Notice of Allowability

10/065,724

RAO ET AL.

FIG. 1 "PRIOR ART"

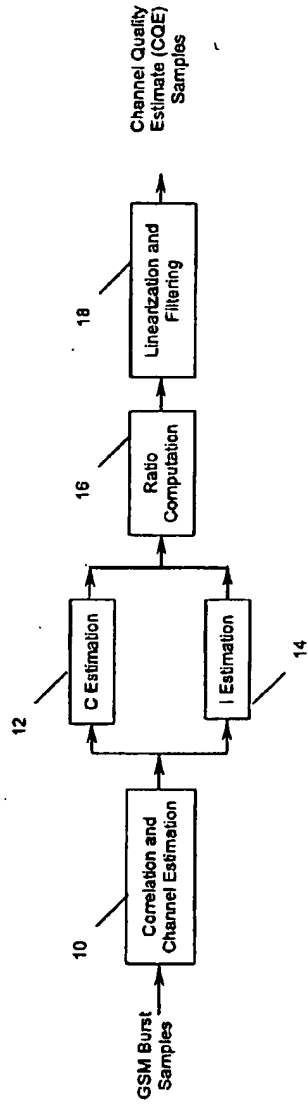
3. The examiner has made the following changes to the drawings: Figure 1 has been amended to include the label as "Prior Art." See specification in page 1. In order to avoid abandonment of the application, applicant must make these above agreed upon drawing changes.

FIG. 2

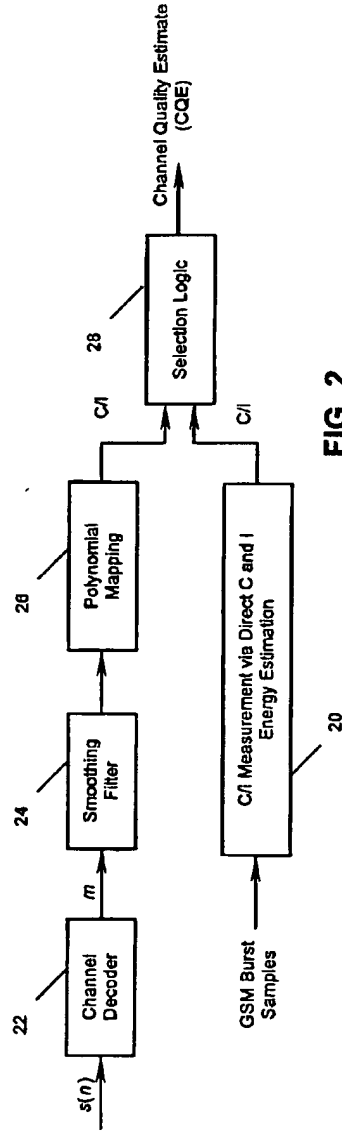
4. The following is an examiner's statement of reasons for allowance: The claimed subject matter in claims 1-14 is allowable because the arts of record fail to teach or fairly suggest the claimed "method of combining a channel quality estimate for a radio channel based on a direct measurement of carrier and interferer energies (f20 fig. 2), and a channel quality estimate (22 and 26) for the radio channel based on channel decoder metrics, to obtain a better overall estimate of the carrier-to-interference (C/I) ratio measure of the channel quality for the radio channel, said method comprising: Obtaining a direct channel quality estimate based on carrier and interferer energies; obtaining a channel decoder metric based channel quality estimate; computing a confidence level, $P(\text{direct})$, for the direct channel quality estimate, and a confidence level, $P(\text{metric})$, for the decoder metric channel quality estimate wherein,

$0 < P(\text{direct}) < 1$, $0 < P(\text{metric}) < 1$, and $P(\text{direct}) + P(\text{metric}) = 1$;
multiplying $P(\text{direct})$ by the direct channel quality estimate and $P(\text{metric})$ by the decoder metric channel quality estimate; and
adding the respective products to obtain a final channel quality estimate in terms of the carrier-to-interference (C/I) ratio for the radio channel" as in claims 1 and 8. See element 28 in fig. 2 and figure 3.
